Independent Environmental Audit 4

Griffith Base Hospital

SSD-9838218, NSW

February 2024

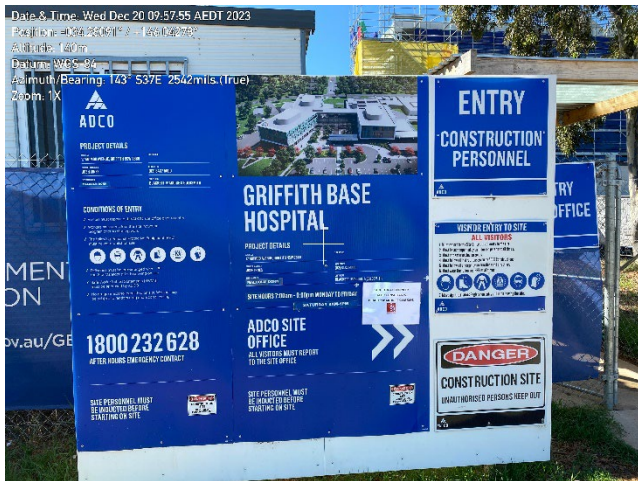
Storage area had been cleared for gravel stockpile and trenching works (refer to right of photo with orange flagging) adjacent to the southern boundary.

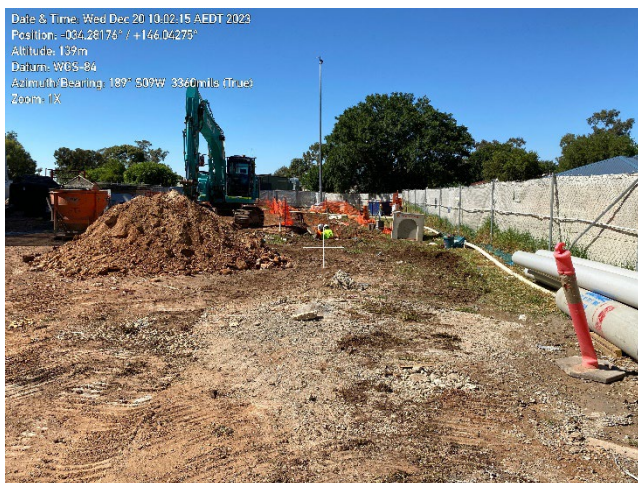
Sedimentation in the gutter down-gradient of the site access on Animoo Avenue.

- Clean up the spoil that had spilled beyond the site boundary in the south-eastern corner of the site, refer to site inspection photographs in Appendix D
- A review is required of erosion and sediment controls at the site construction access to ensure that with ongoing wet weather, mud tracking on to local roads and sediment-laden water movement down-gradient along Animoo Avenue is minimised, refer to Appendix C. Consider engaging a clean-up crew / street sweeper to remove sedimentation in the gutter a time when cars can be excluded from parking.
- Refix signage on the flammable cabinet, refer to site inspection photographs in Appendix D
- Update the timing in the Staging Plan to reflect more accurate timing
- Maintain the Project website with all the environmental assessments, EIS, Response to Submissions and the Modification 1 Report.
